Operating Requirements Under Subsequent License

From: Kubit, Robert (DEP) [Robert.Kubit@state.ma.us]
Sent: Friday, December 17, 2010 1:18 PM
To: Webb, Kevin (Enel North America)
Cc: Melissa_Grader@fws.gov; Caleb Slater (Caleb.Slater@state.ma.us)
Subject: RE: Request for Comments: Run-of-River and Minimum Flow Monitoring Plan for Glendale
Follow Up Flag: Follow up
Flag Status: Red

Re: Glendale Hydroelectric Project (FERC No. 2801)
Run-of-River and Minimum Flow Monitoring Plan

REF: FERC No. 2801
Littleville Power Company, Inc.
Glendale Project
Comments on Run-of-River and Minimum Flow Monitoring and Compliance Plan

MINI-HYDRO CONCEPT A
UNIT LAYOUT PLAN
SCALE: $\frac{1}{8}" = 1'-0"$

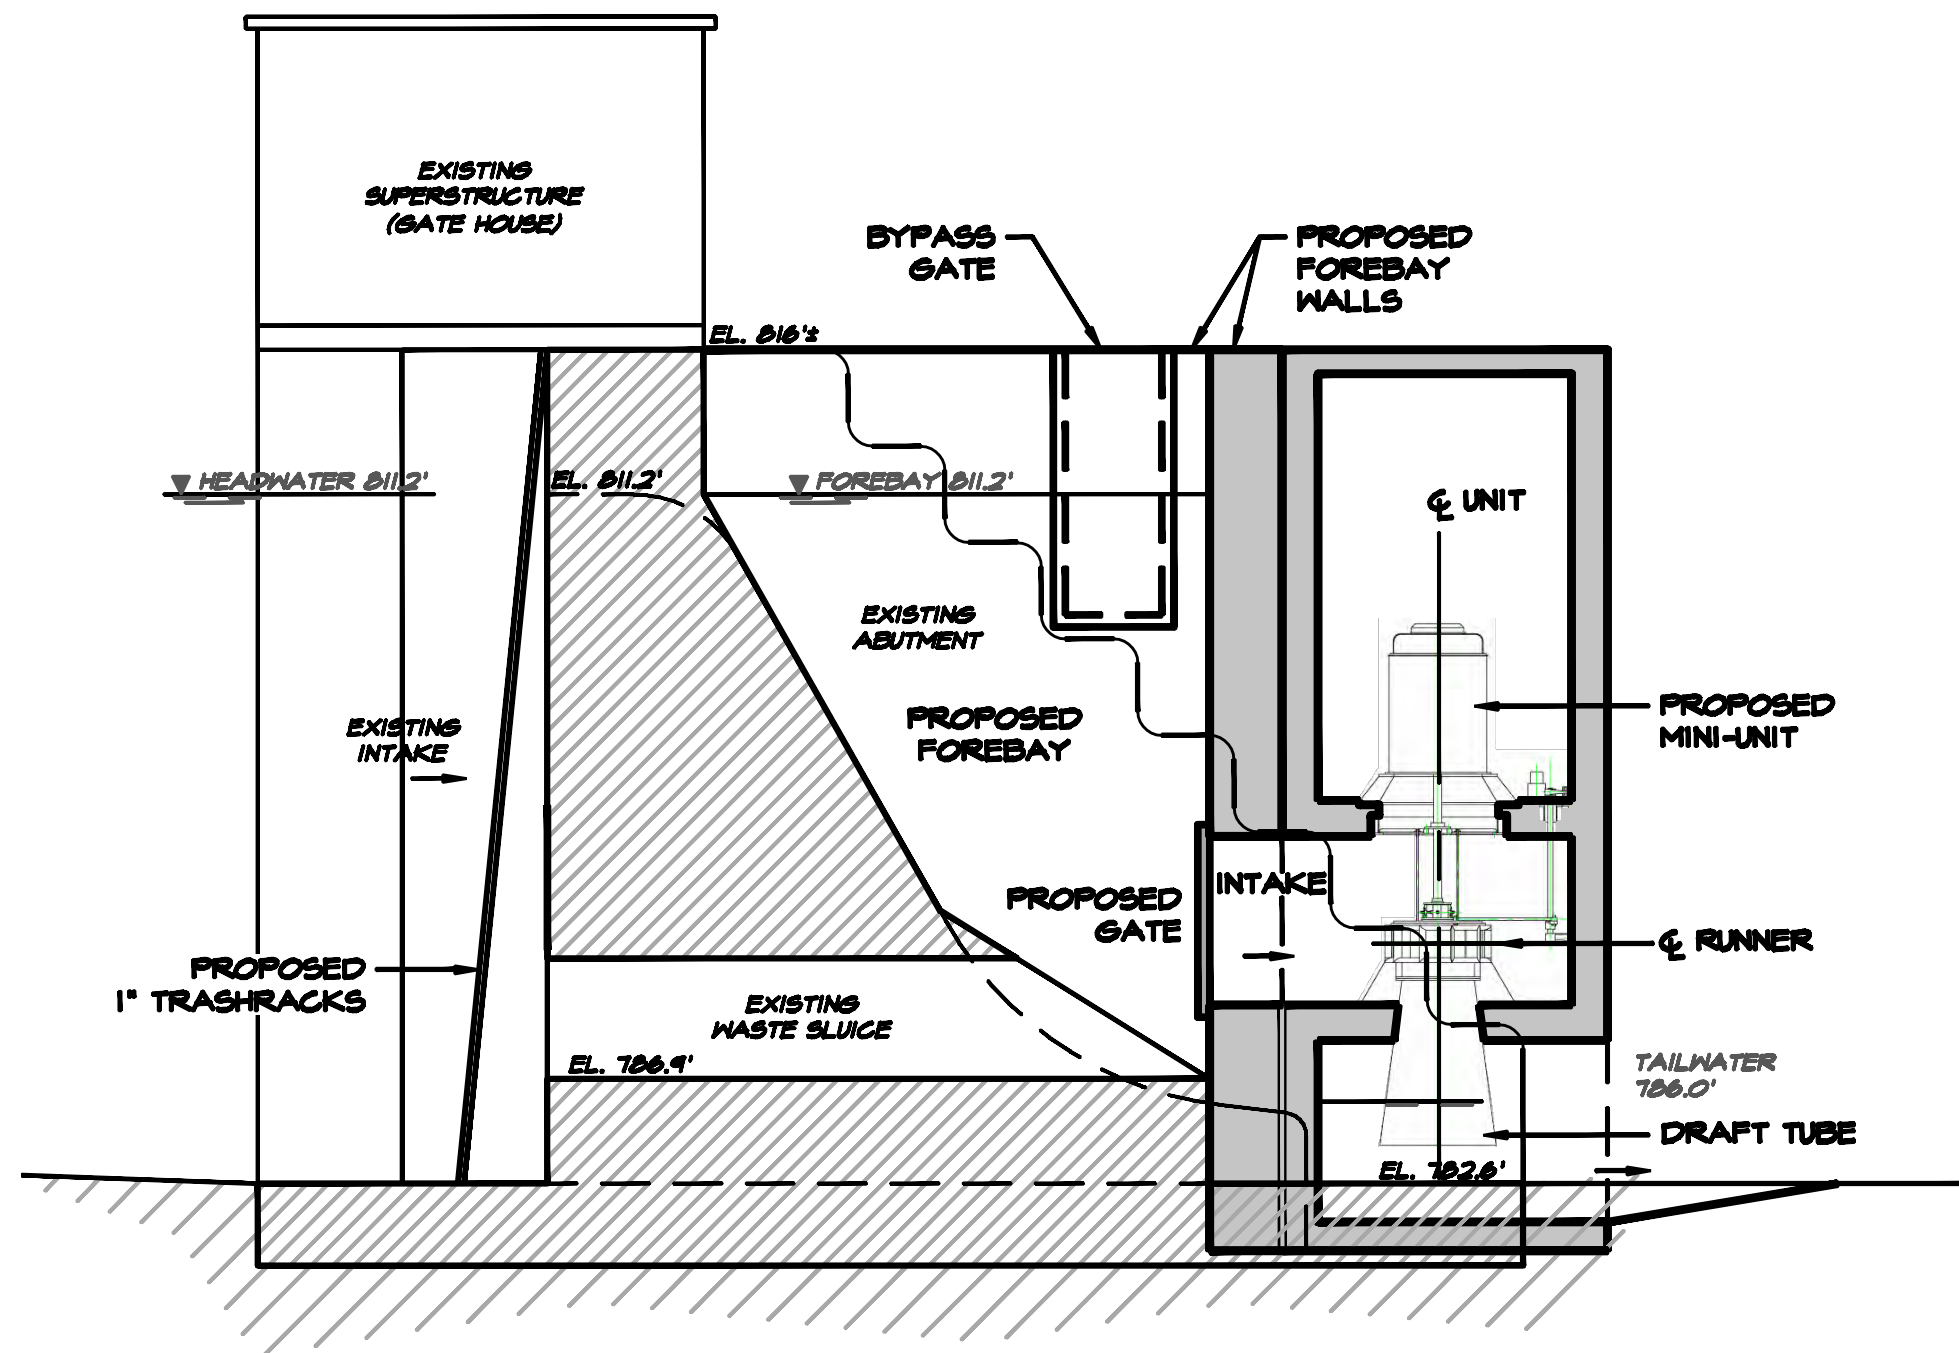
- *it would be helpful to include a plan-view drawing of the project that delineates the headpond, gatehouse, new forebay and associated structures, and the location of the headpond sensor.*

A plan view of the gatehouse showing the above features is provided in Attachment A.

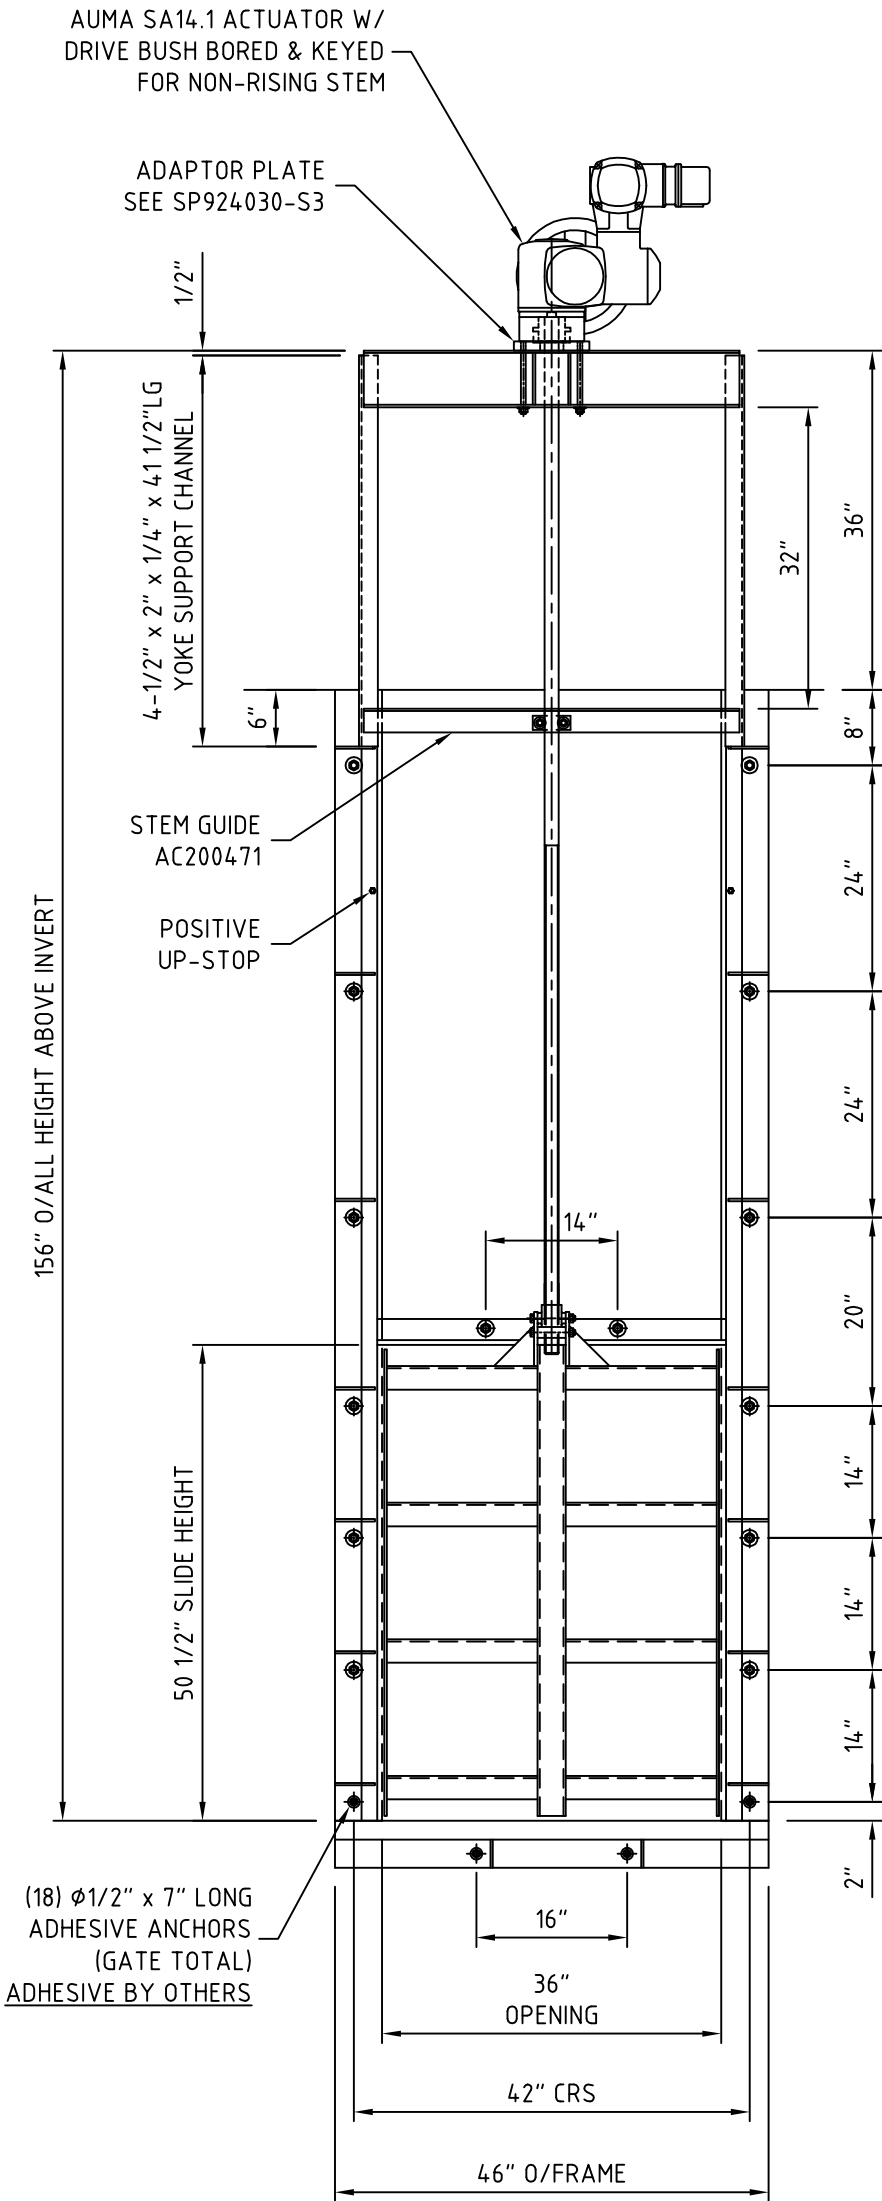
- *the Plan should include details on the slide gate dimensions and a calculation sheet verifying that the gate will be sized to pass 90 cfs; and*

Details of the bypass gate's dimensions and flow calculations are provided in Attachment B and are discussed under New Minimum Flow Unit, above.
